RE: Draft Environmental Impact Statement and Section 404 Permit Applications for the Texas Central Railway, LLC Proposed Dallas to Houston High-Speed Rail Project (Dallas, Ellis, Freestone, Grimes, Harris, Leon, Limestone, Madison, Navarro, and Waller Counties)

Texas Parks and Wildlife Department Comments

Texas Central Railway, LLC Proposed Dallas to Houston High-Speed Rail Project
Draft Environmental Impact Statement, and Section 404 Permit Applications
(Fort Worth District - SWF-2011-00483 and Galveston District – SWG-2014-00412)
Dallas, Ellis, Freestone, Grimes, Harris, Leon, Limestone, Madison, Navarro, and Waller Counties

Figure 1: Fort Boggy State Park

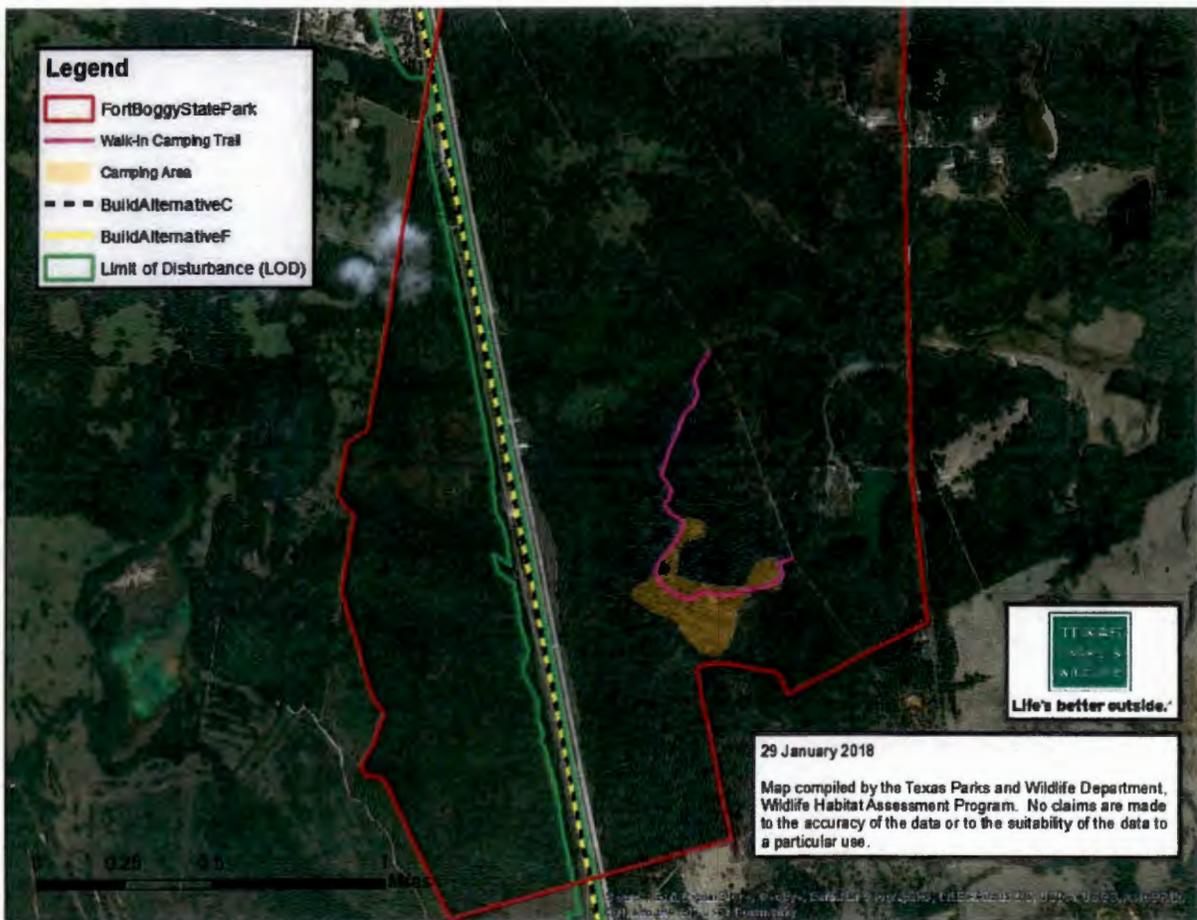
Section 3.17 regarding recreational facilities briefly discusses noise impacts and dismisses the need for evaluation of noise impact to Fort Boggy SP because no park amenities are located within the Project's 0.25-mile study area for indirect impact to recreational facilities. Fort Boggy SP contains one overnight campsite that is within 0.25 mile of the proposed LOD as shown in Figure 1.

Recommendation: TPWD recommends an extensive noise impacts evaluation on Fort Boggy SP's visitors and wildlife in the EIS. The entire property is parkland that would allow for future trails and camping areas upon adequate funding, thus the draft EIS should assess noise impacts for any portion of the property within the study area, regardless of whether existing amenities are present in the study area. TPWD recommends assessing noise within Fort Boggy SP at the ROW of the Project, at the one-quarter mile mark from the LOD on each side of the Project alignment during winter months when deciduous trees would be in leaf-off conditions, and at the existing campsite. The evaluation should take into consideration the basin-like topography of the landscape and the potential for noise to echo across the park greater than the one-quarter mile study area distance. Noise impacts on Fort Boggy SP should also be incorporated in *Chapter 4.0 Indirect and Cumulative Impacts*.
